# ADDENDUM NO. 5

Greenfield Central High School Auditorium Renovation and Addition – Bid Package No. 1 810 N. Broadway Greenfield, IN 46140

# ADDENDUM NO. FIVE

PROJECT: GREENFIELD CENTRAL – AUDITORIUM RENOVATION AND

**EXTERIOR ELEVATIONS**

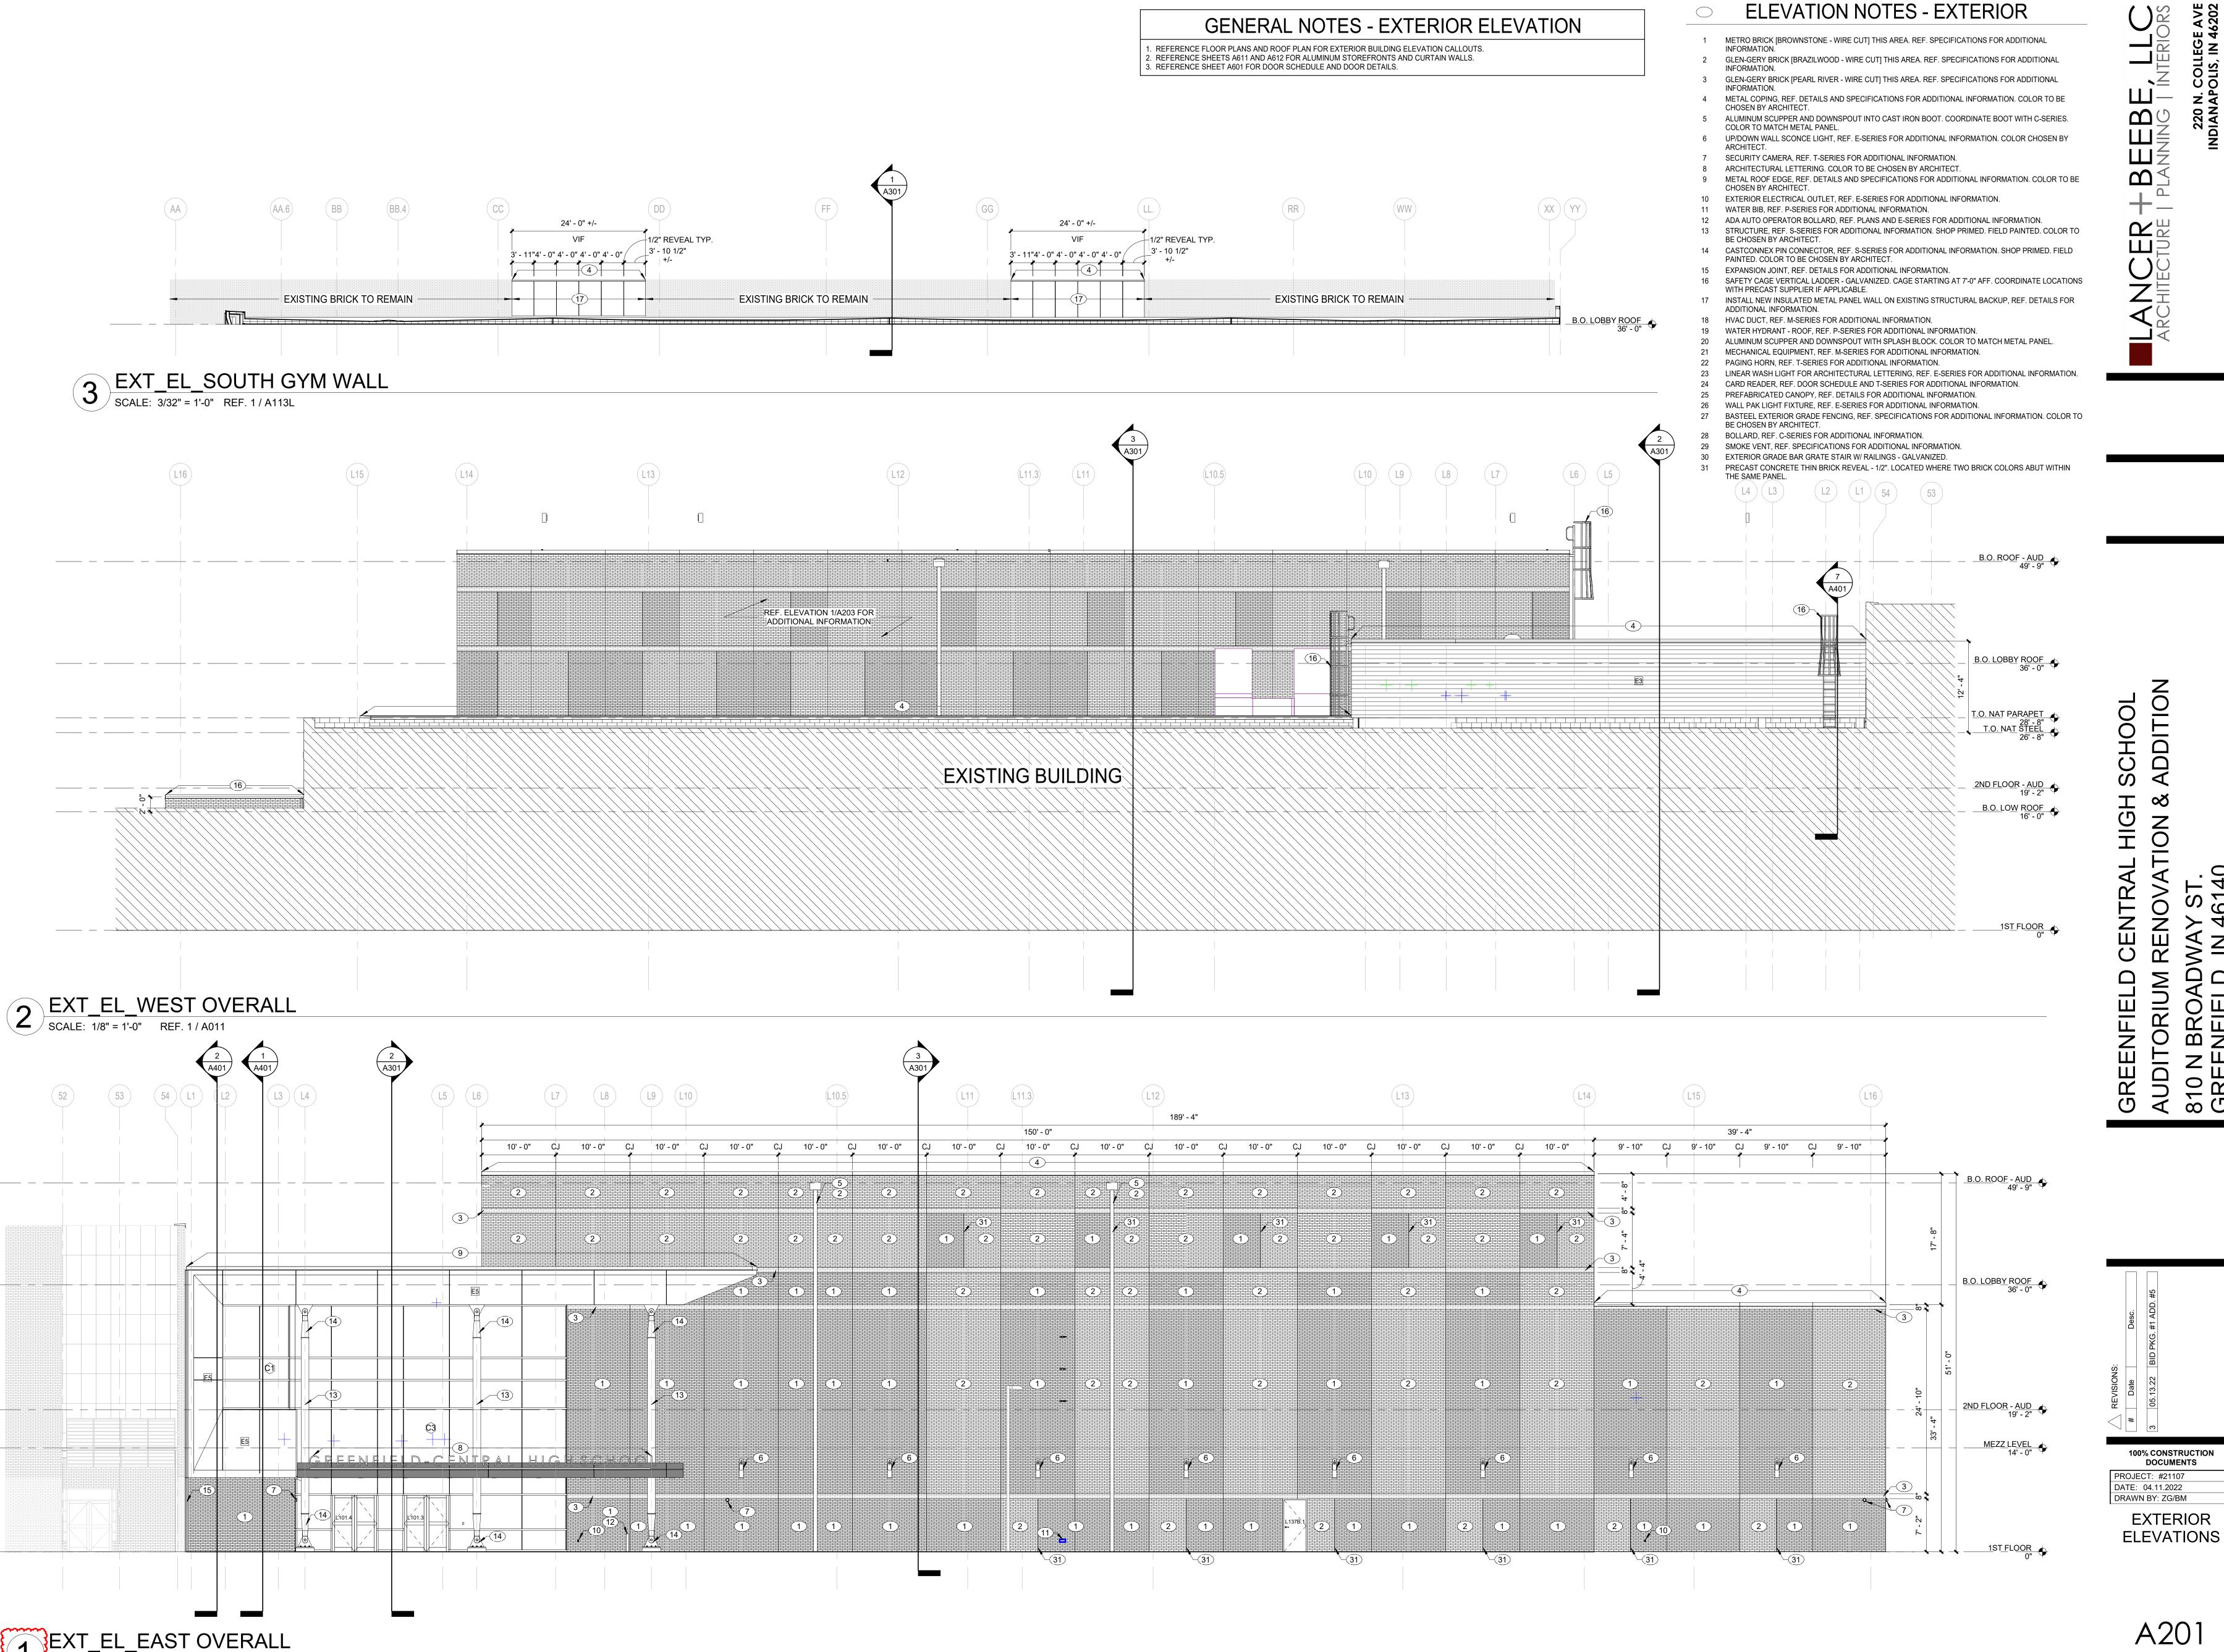
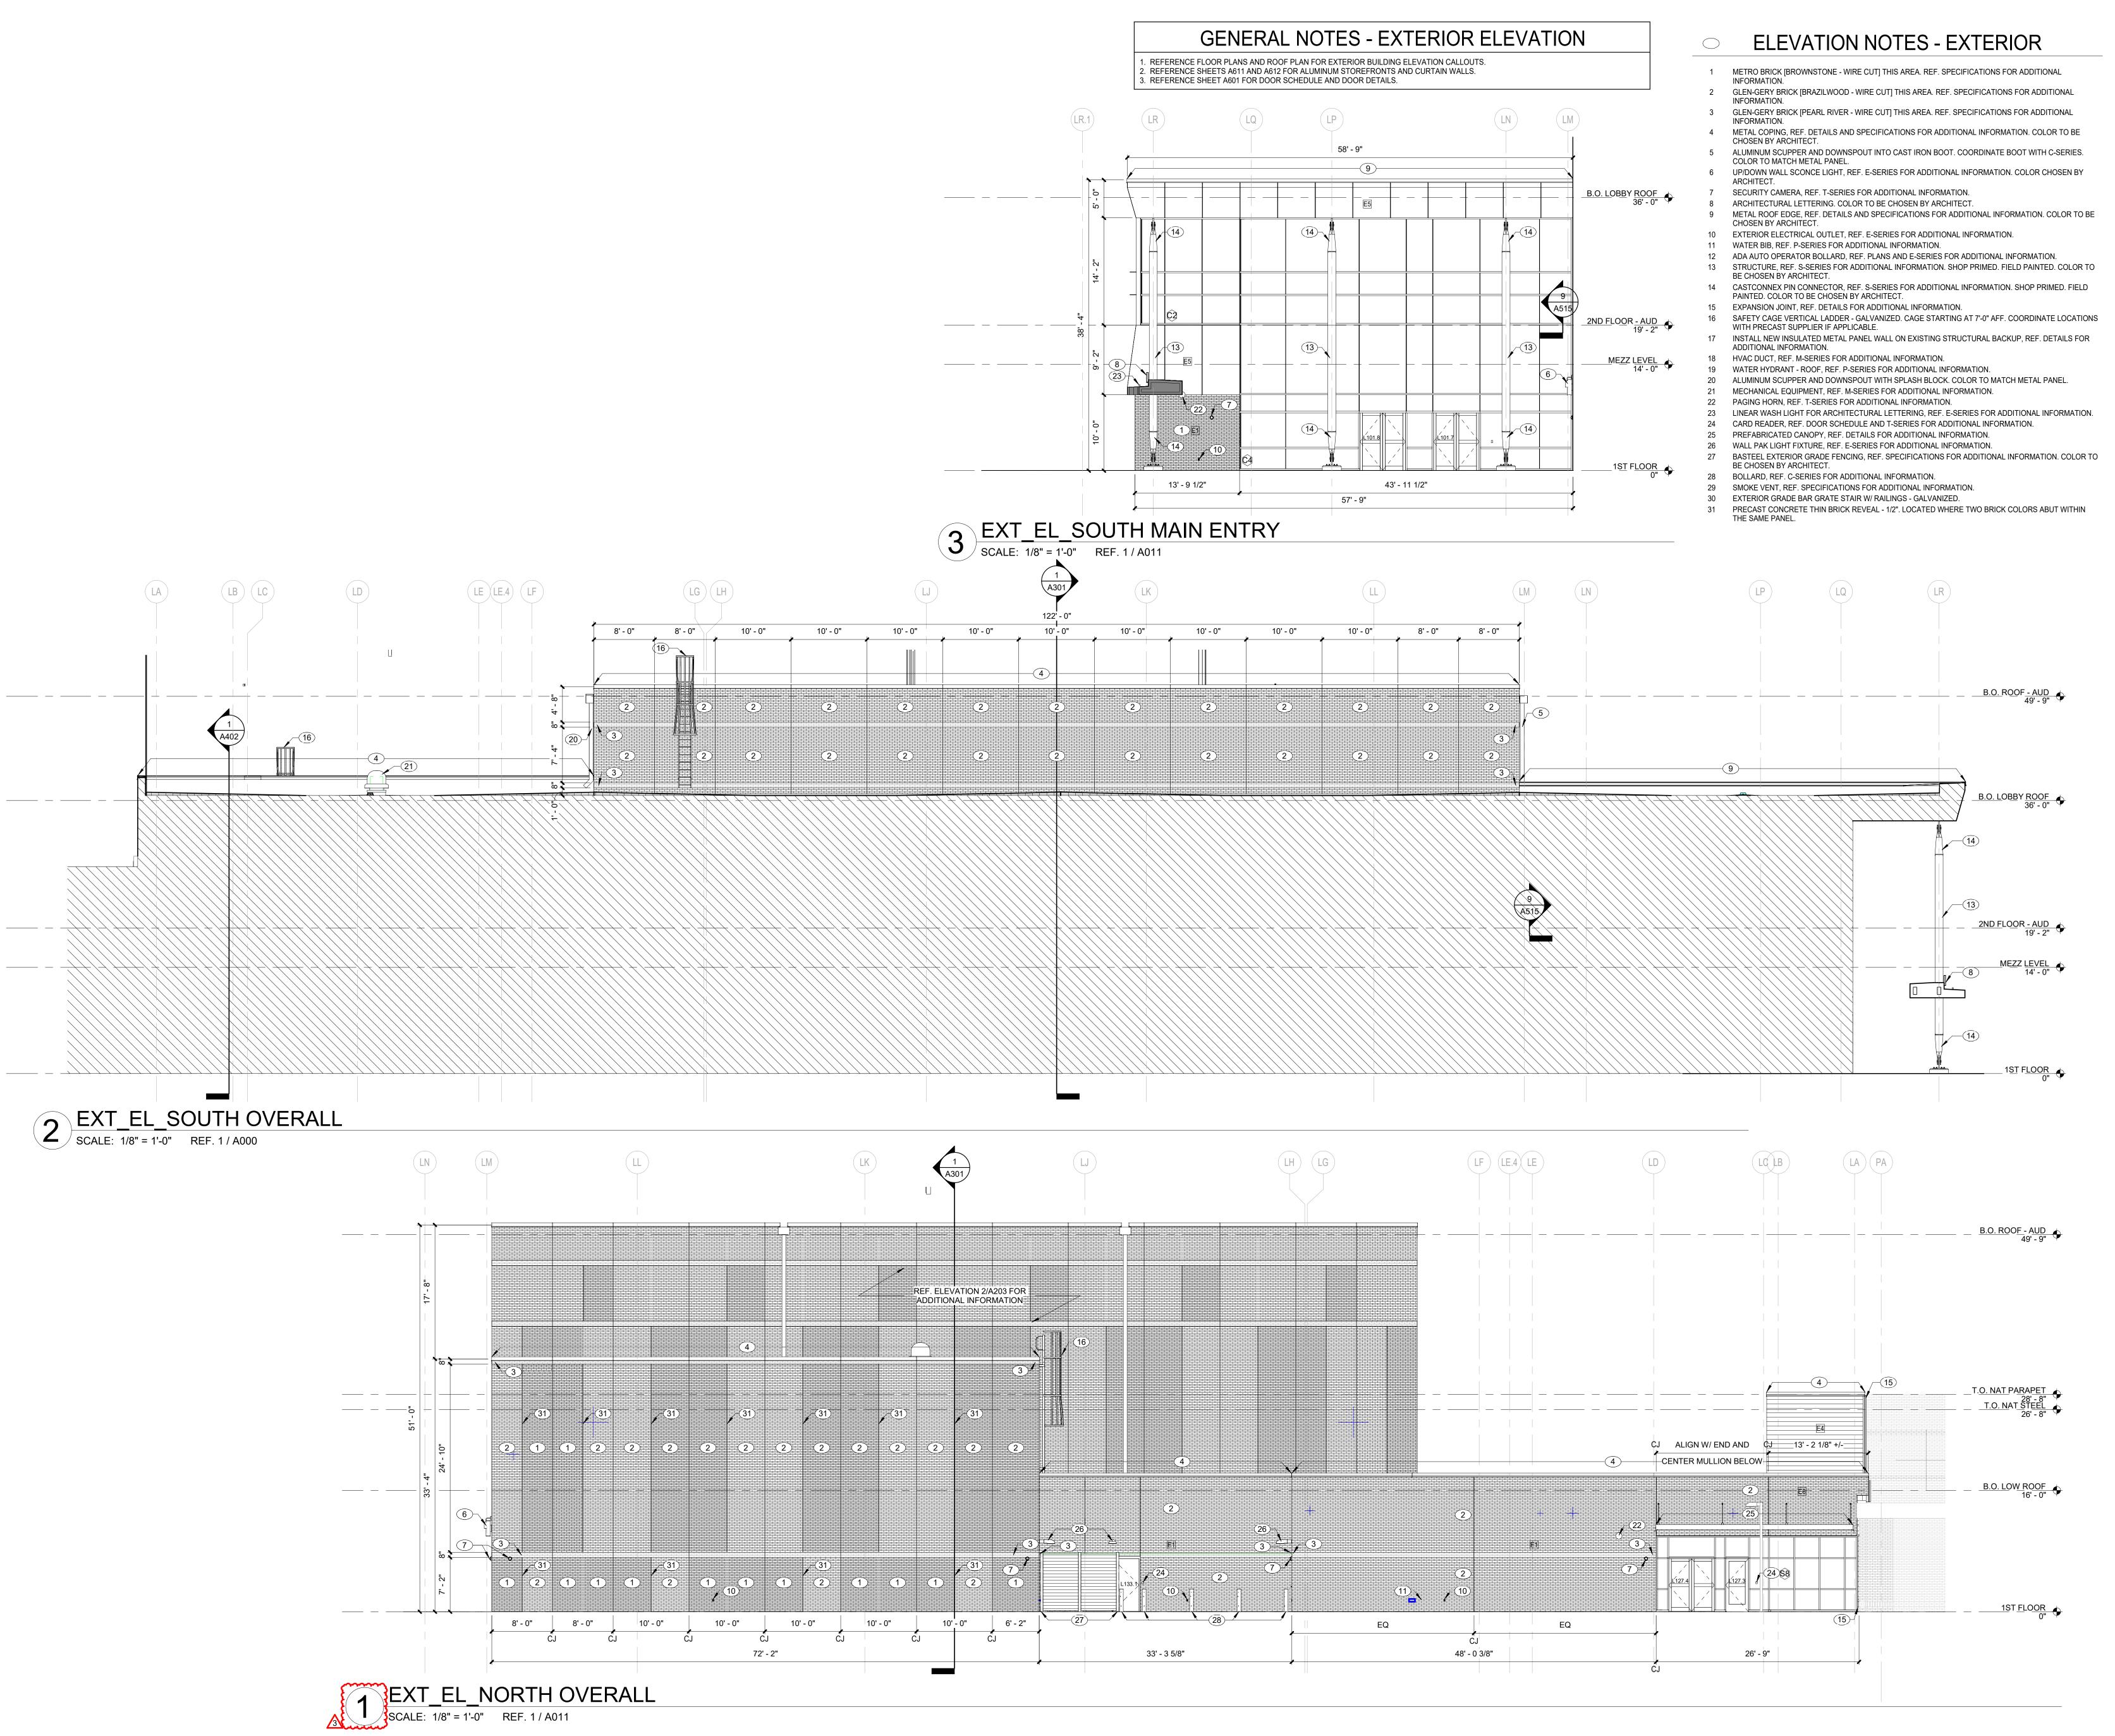
3	4/28/2022	L+B	Please not Item 2.14, B., 3.(thin brick type 3), per the Exterior Elevation Notes on sheets A201, 202, and 203, Glen Gery Brick noted should be Pearl River, Wire Cut, not Brazilwood, Wire cut. Please confirm? Please be advised that thin brick lead times are not controlled by the precaster and could affect the project schedule if the thin brick material is not available/received at the precast plant in time to meet the casting schedule	4/28/2022	CORESLAB	See revised specification issued in Addendum No. 5.
4	4/28/2022	TSC	Are electrical boxes and conduits going to need to be cast into the precast panels? If so, please confirm that the electrical hardware will be furnished by others to the precast plant prior to casting by Others. Also, can we be given an estimated quantity of electrical hardware that will need to be cast in?	4/28/2022	CORESLAB	Yes, these items will be furnished by the Electrical/Low Voltage Contractor to the Bid Category No. 2 Contractor. Please refer to the bid documents to determine quantities and locations.
